Geometrical product specifications (GPS) — Geometrical tolerancing — Tolerances of form, orientation, location and run-out

TECHNICAL CORRIGENDUM 1

Technical Corrigendum 1 to ISO 1101:2012 was prepared by Technical Committee ISO/TC 213, *Dimensional and geometrical product specifications and verification*.

Page 26, 12.2, Figure 53 a)

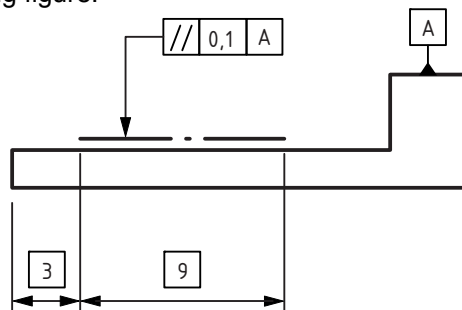
Replace the figure with the following figure:
